SKAGIT RIVER HYDROLOGY INDEPENDENT TECHNICAL REVIEW FINAL REPORT

**Prepared for: Skagit County Department of
Public Works**

Prepared by: Northwest Hydraulic Consultants

April 2007

Figure 3

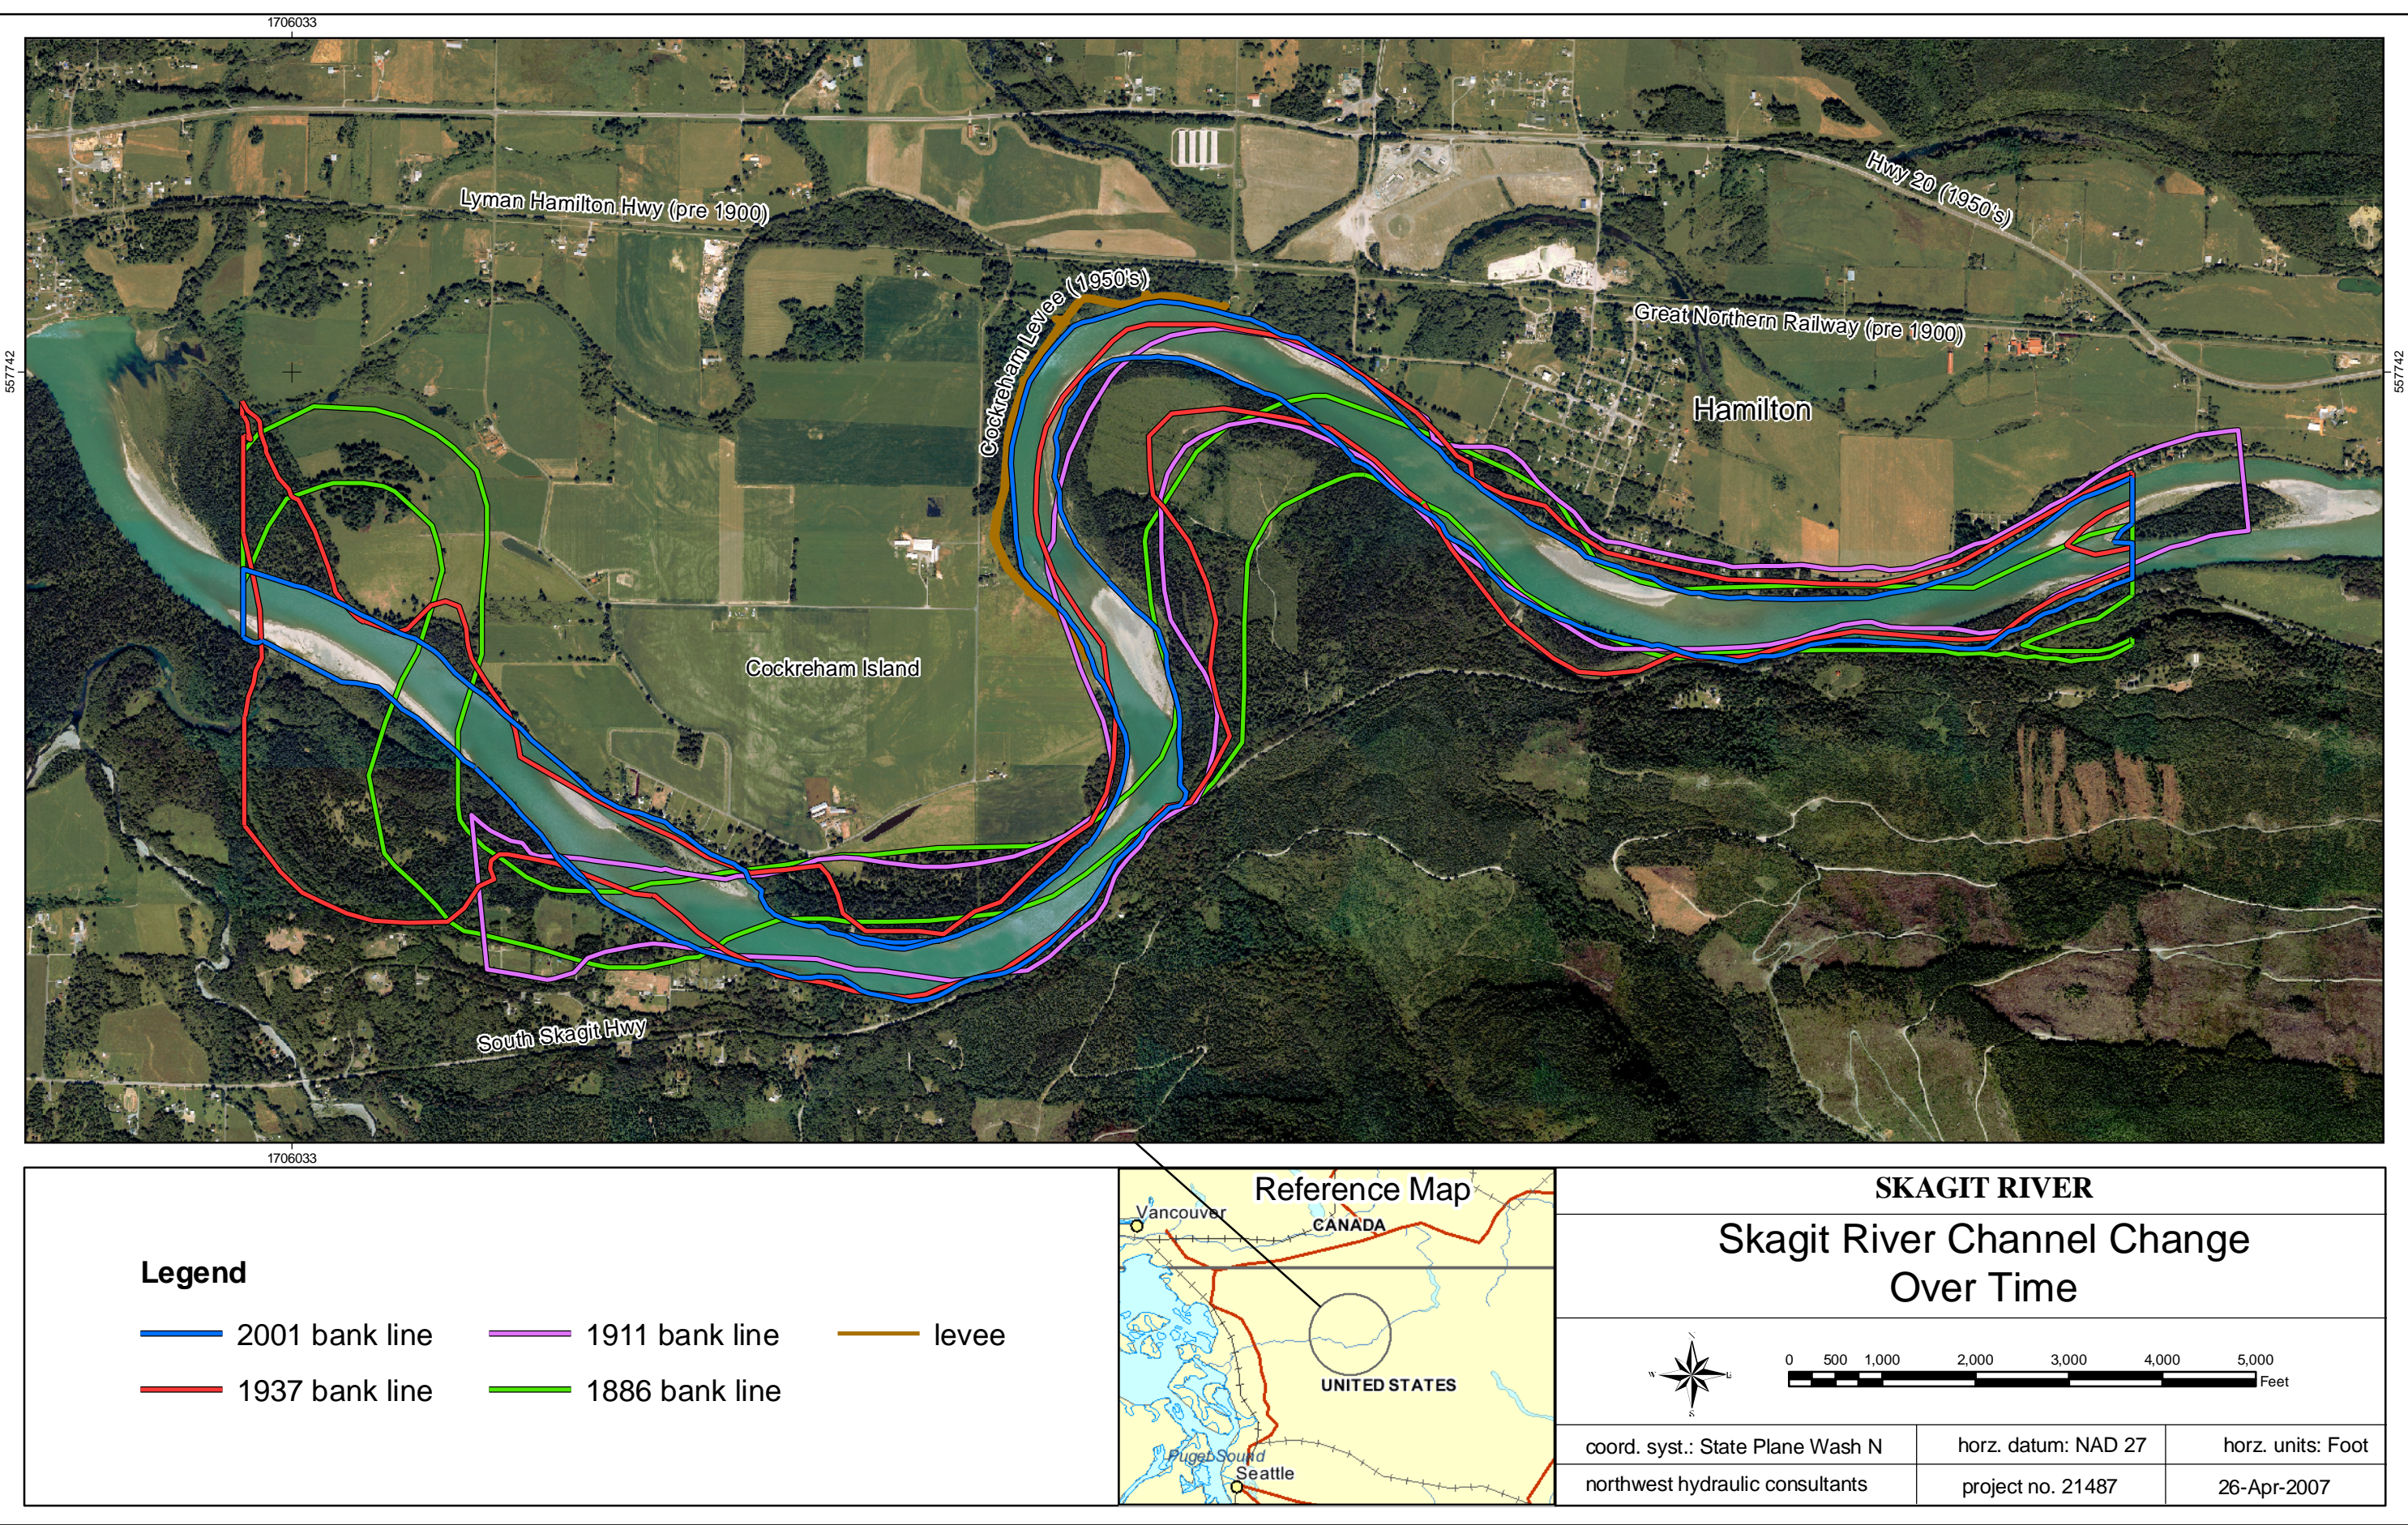
5. page 8: I will attach the pdf file of the COE 1911 map of the Hamilton reach. Maybe that could be incorporated into the migration map on figure 3. **The 1911 banklines have been added to Figure 3 and the text modified. The 1911 bank lines are similar to or wider than those of 1937 and if anything reinforce our conclusions that the river could have carried appreciably more water at the time of the historic floods.**

appears to show the Skagit River in a position much more closely aligned to where the river is today than where it was in 1937. What I believe it shows us is that the river was in the process of widening itself after the 1897 and 1909 flood events, or more likely then not, due to the log rafts being floated down the Skagit during that time, the log rafts played a substantial part in erosion of the Skagit banks and the widening of the Skagit River.

NHC RESPONSE: Bank lines from the COE map of 1911 will be added to Figure 3 of our report and text will be modified accordingly. The 1911 bank lines are similar to or wider than those of 1937 and our opinion remains that because of channel changes between 1886 and present, it is not possible to demonstrate that the Smith House would (or would not) have flooded at a discharge of 240,000 cfs in 1921. Fundamentally, information is not available to the necessary standard to reach a definitive conclusion on this issue. Prompted by a comment from Chal Martin we have done some sensitivity runs with the hydraulic model which demonstrate that with the magnitude of channel changes from past to present, it is quite possible that the river could have carried 240,000 cfs or more in 1921 without flooding the Smith House. The text will be modified to make reference to the sensitivity runs.
